NOT FOR CONSTRUCTION	JOB NUMBER	953-20
	REVISIONS	
	12-17-20	PER COMMENTS
	2-4-21	PER COMMENTS
ORIGINAL DATE	10-1-20	
DRAWN BY	JM	
DESCRIPTION	LANDSCAPE PLAN	
SHEET NO.	L1.1

WOODMEN HILLS REC CENTER
 9211 MERIDIAN RANCH BLVD.
 PEYTON, CO 80831
 EL PASO COUNTY, COLORADO

Landscape Plan_V3.pdf Markup Summary

LANDSCAPE PLAN AREA-B

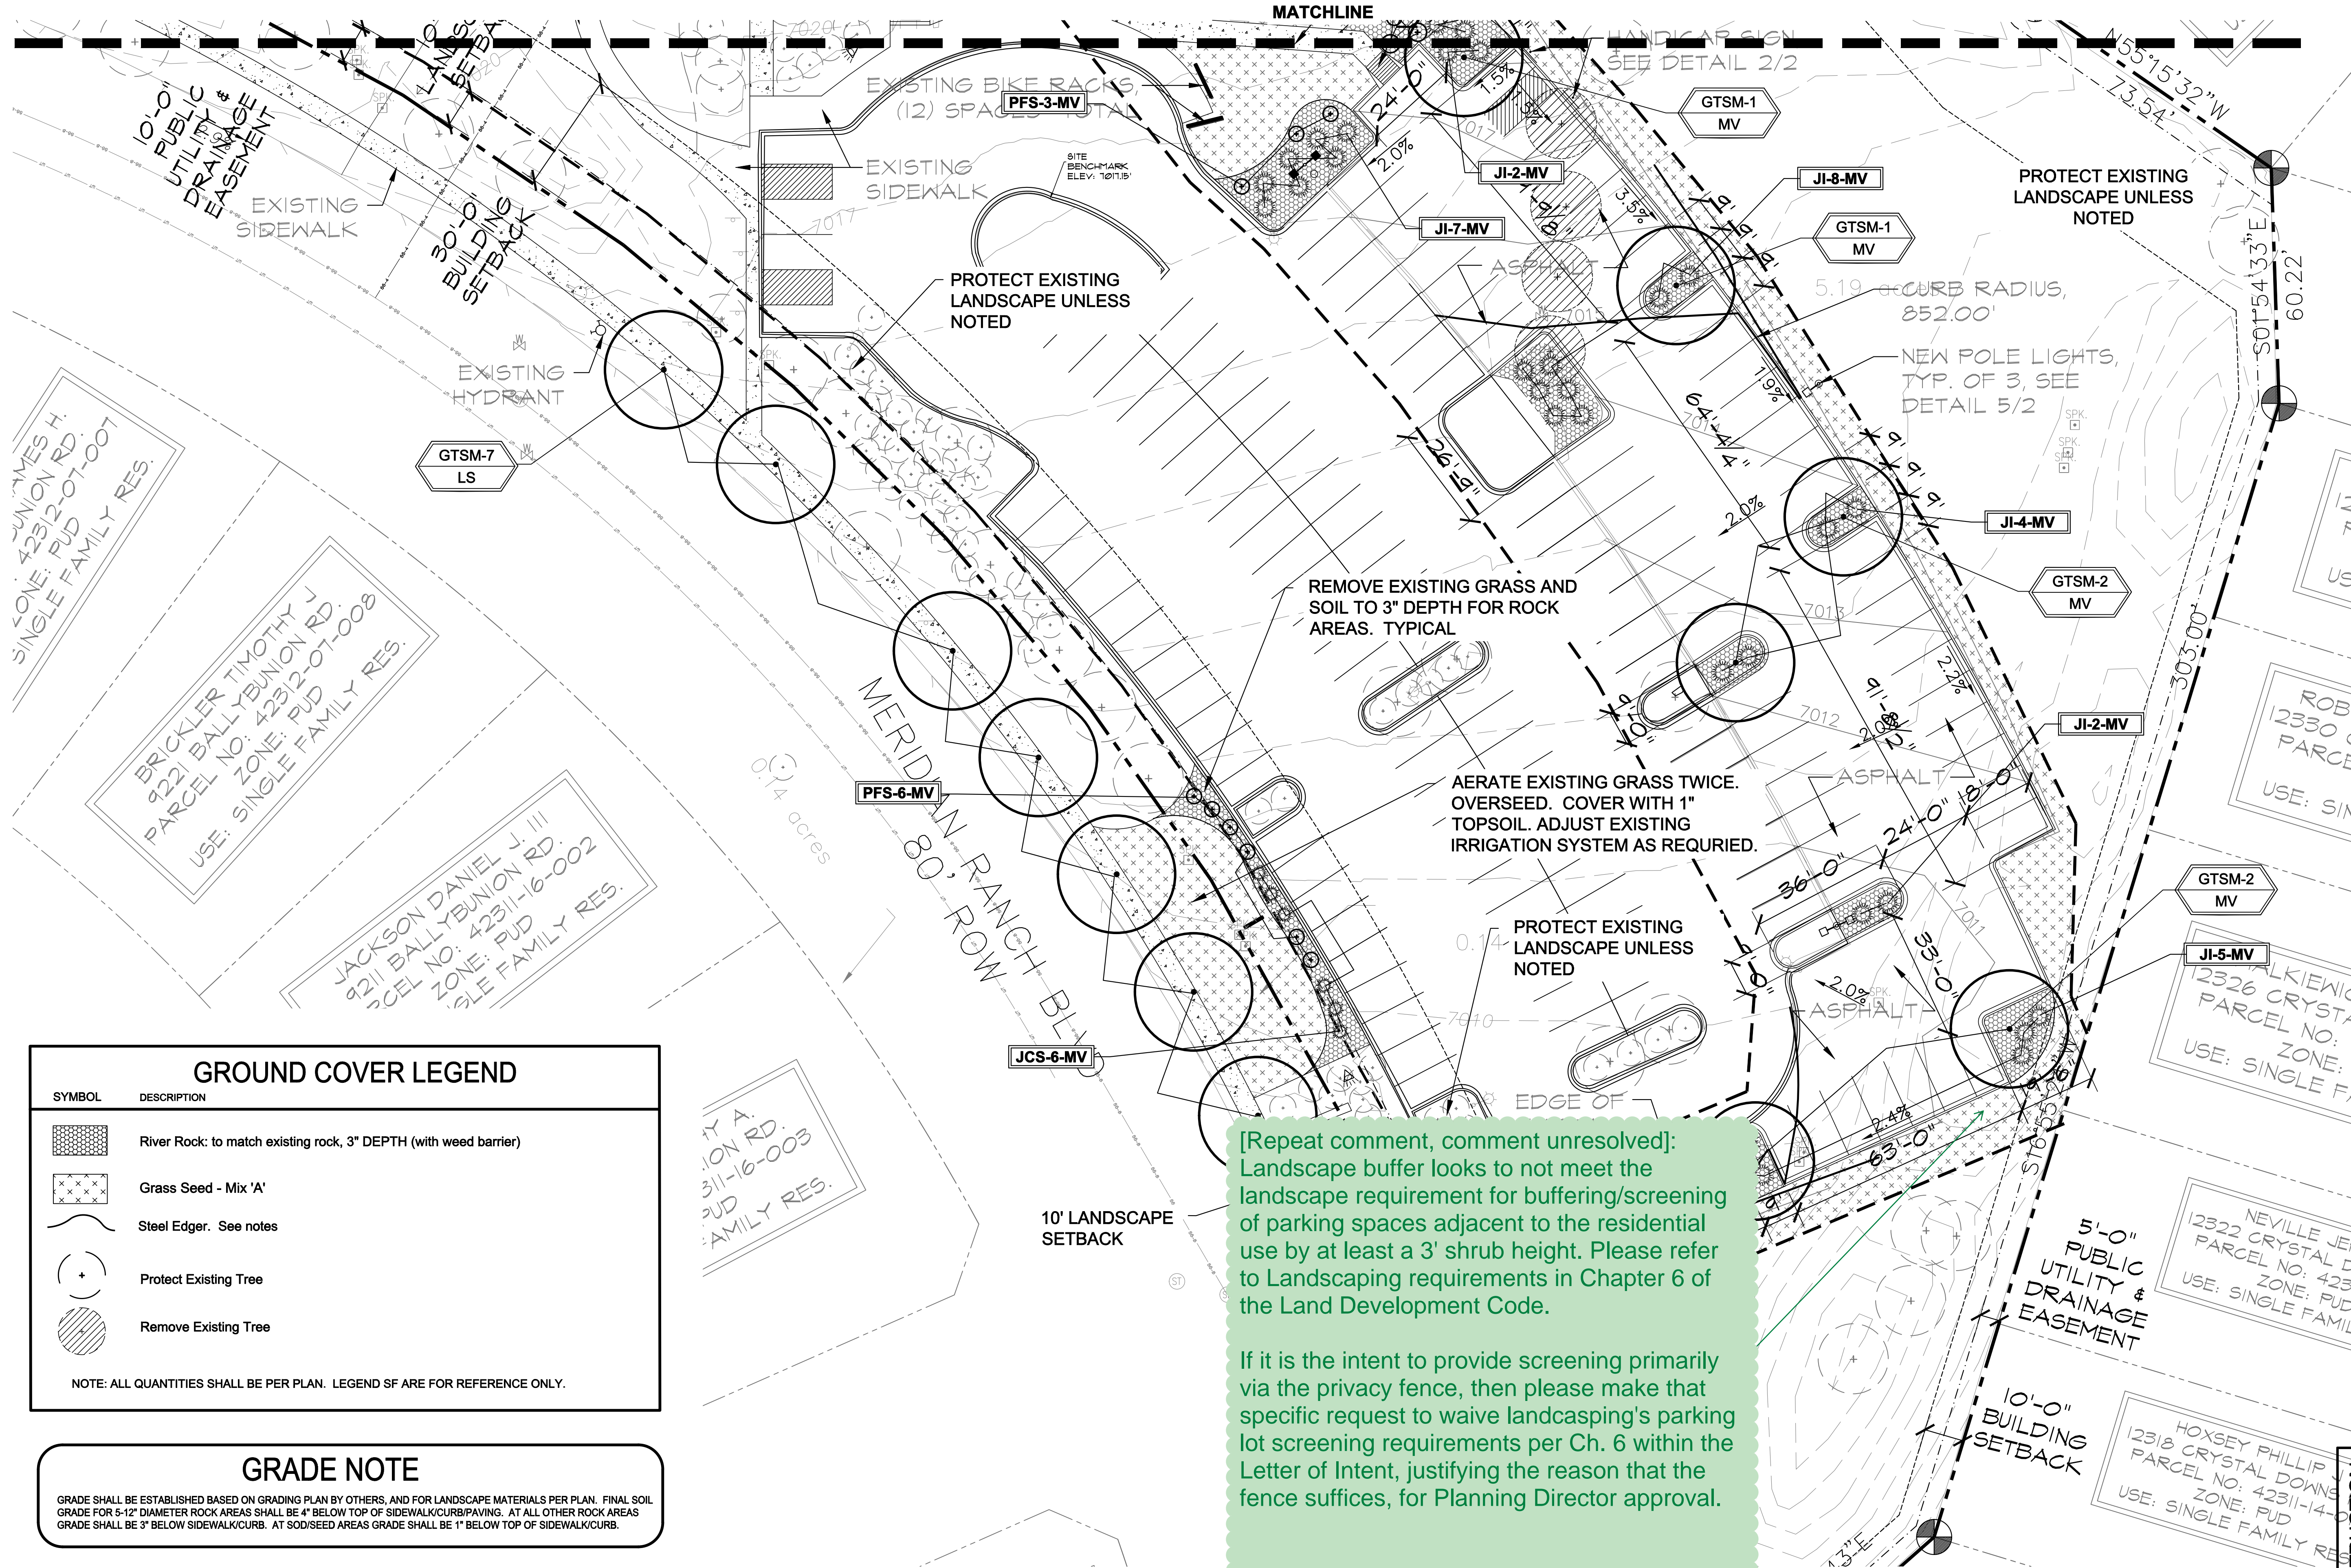
[Repeat comment, comment unresolved]: Landscape buffer looks to not meet the landscape requirement for buffering/screening of parking spaces adjacent to the residential use by at least a 3' shrub height. Please refer to Landscaping requirements in Chapter 6 of the Land Development Code.

If it is the intent to provide screening primarily via the privacy fence, then please make that specific request to waive landscaping's parking lot screening requirements per Ch. 6 within the Letter of Intent, justifying the reason that the fence suffices, for Planning Director approval.
